Docket Item # 2  
BAR CASE # 2009-0057

BAR Meeting  
April 22, 2009

**ISSUE:** Alterations to previously approved plans  
**APPLICANT:** Boys and Girls Club by Stephanie Dimond  
**LOCATION:** 401 North Payne Street  
**ZONE:** RB/Residential

**Figure 2. Photo of west and north elevations**

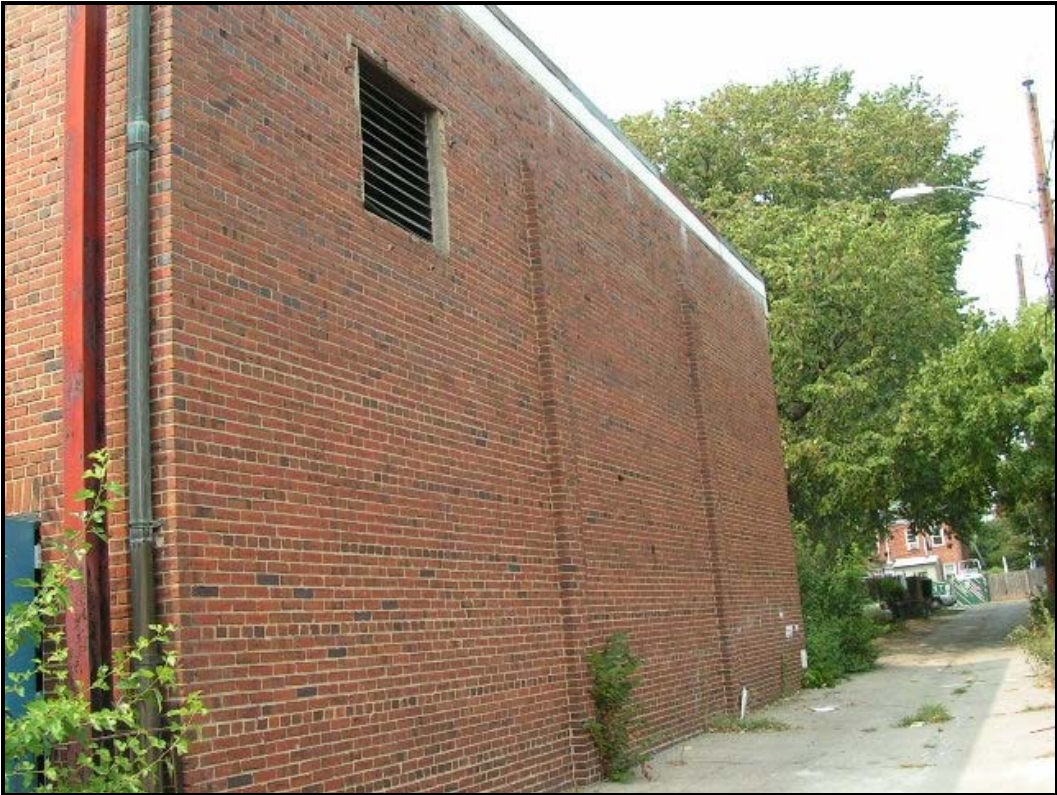
Instead of the previously approved six panel wood front door with a transom, the applicant now proposes a smaller four panel steel door package with multi-light sidelights and a transom. During construction it was discovered that the front entrance was larger than expected and the originally proposed door was not wide enough to span the opening. For ADA compliance purposes the applicant now proposes the single door with sidelights. Although the steel door, sidelights and transom are proposed to be installed as a single unit, the transom and sidelights, as well as the trim, will be clad with wood and painted white. The door will be painted black.

In general, Staff is supportive of the applicant's request for alterations to the Boys and Girls Club, with one exception. Staff does not support the use of the steel frame door, including sidelights and transom, at the entrance to the facility and believes that the door and associated features should be constructed entirely of wood. Although the *Design Guidelines* state that "exterior flush or paneled metal doors may be appropriate in certain limited circumstances for 20<sup>th</sup> century retail, commercial or industrial buildings," Staff believes that the steel door is a significant departure from the Colonial Revival vocabulary and traditional materials used on this 1930s community building. Staff also recommends that the door have six panels, not four, as this is more typical of the Colonial Revival style buildings.

1. That the front door, transom and skylights be constructed of wood and not steel; and,
2. That the front door have six panels, not four.

Figure 5. Existing east and north elevations.

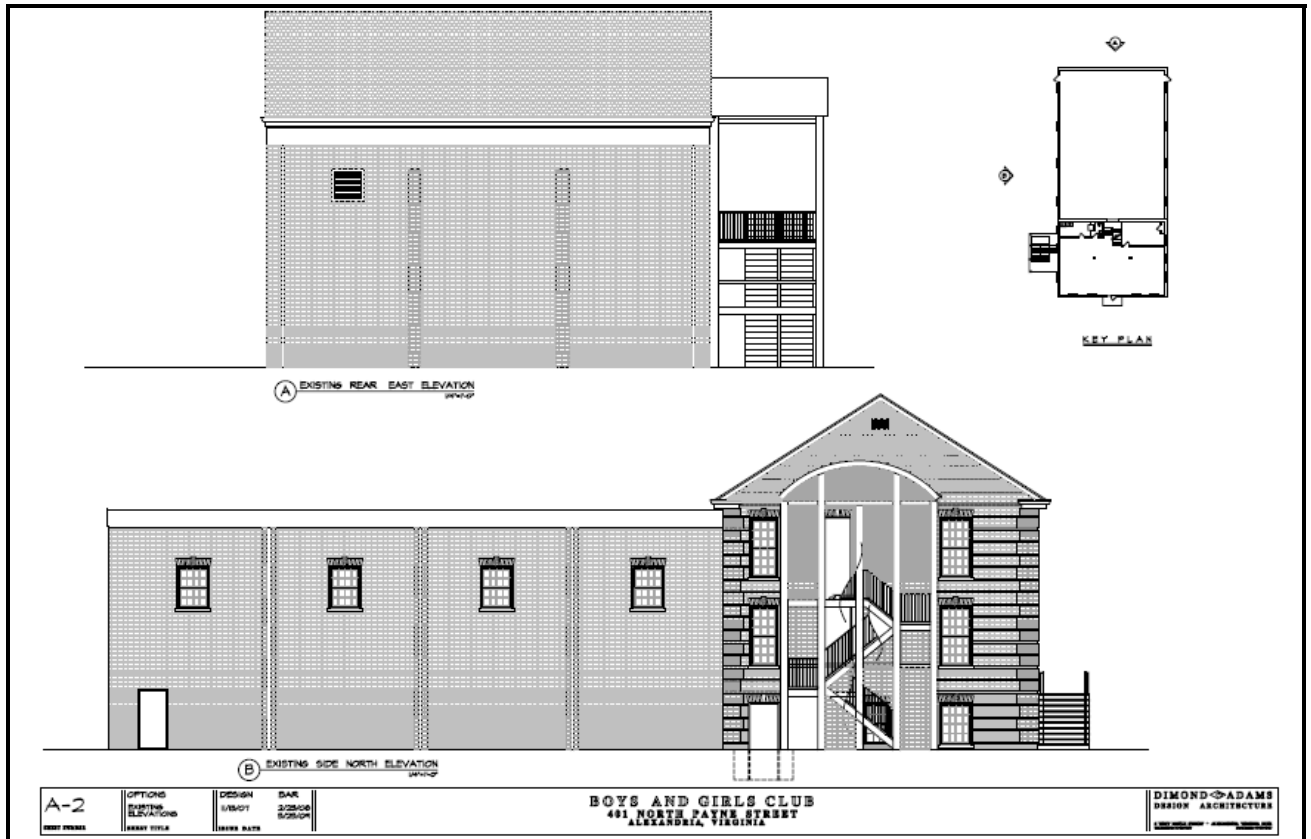
The existing 3 ½ foot by 3 ½ foot exhaust vent on the east elevation of the gymnasium is no longer needed and is proposed to be filled in with brick. The brick used in the recessed opening will match the existing brick as closely as possible.

The existing steel door on the north elevation of the gymnasium will be removed and the opening will be enlarged to accommodate a pair of steel doors to facilitate the moving of large equipment – such as pool tables – into the building. The doors will be painted black.

Staff has no objection to the flush steel doors along the north elevation of the gymnasium because they are located on the more utilitarian portion of the building over 100 feet from North Payne Street where they will be less visible. Furthermore, the doors will be painted black, allowing them to blend into the background of the long brick facade.
